Subject: Work Plans for the Rifkin Property, 4525 to 4563 Horton Street, Emeryville, California

**Work Plan for Sample Collection and Laboratory
Analysis of Building Material and Precipitate on a
Portion of the Rifkin Property
4525 to 4563 Horton Street,
Emeryville, California**

**November 20, 1996
LF 3402.95-004
(Revision 1)**

Figure 1

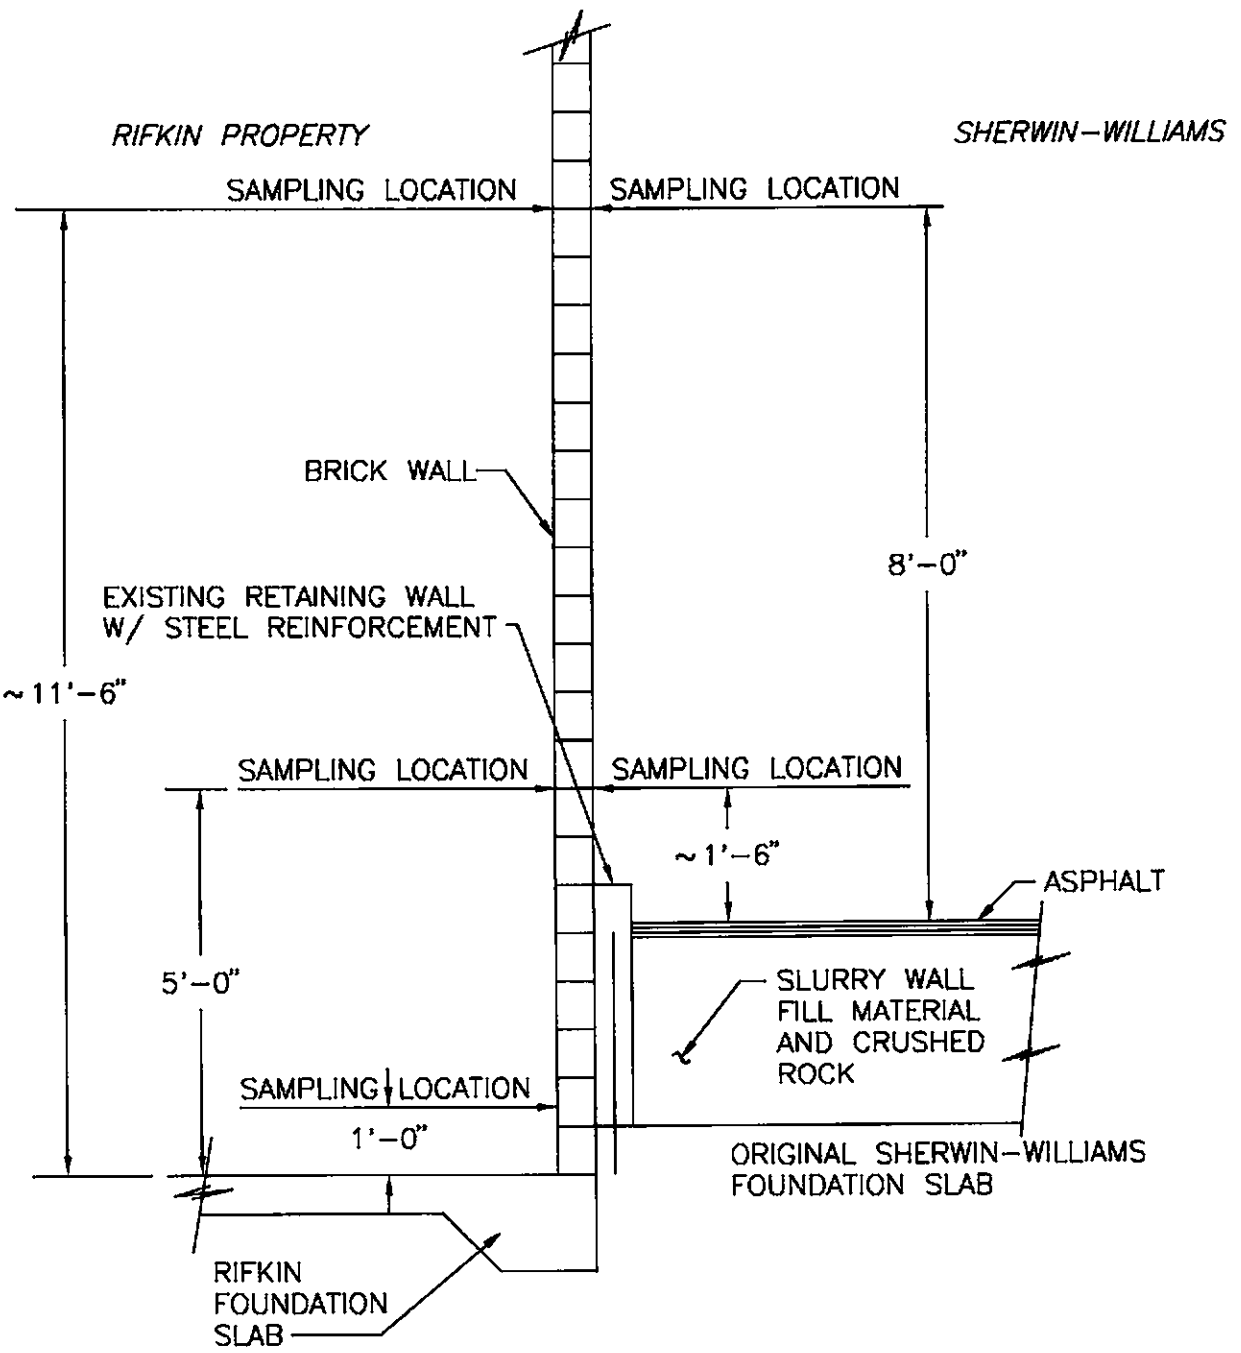
The work plan involving building material sampling has been revised (the previous version was dated November 7, 1996) to address comments raised by Chiron. This work plan describes the proposed scope of work to evaluate the potential migration of arsenic into the brick wall and/or mortar at the Rifkin Property adjacent to the Sherwin-Williams site.

To evaluate the potential migration of arsenic from the Sherwin-Williams Site into building materials at the Rifkin Property, we propose to collect samples of brick, mortar, precipitate (if any), and paint chips (if any) at each of four locations along the southern wall of the Building. Sampling will be conducted along interior and exterior faces of the southern wall at locations approximately 40 feet (ft), 80 ft, 120 ft, and 160 ft from the southwestern corner of the building (see Figure 1).
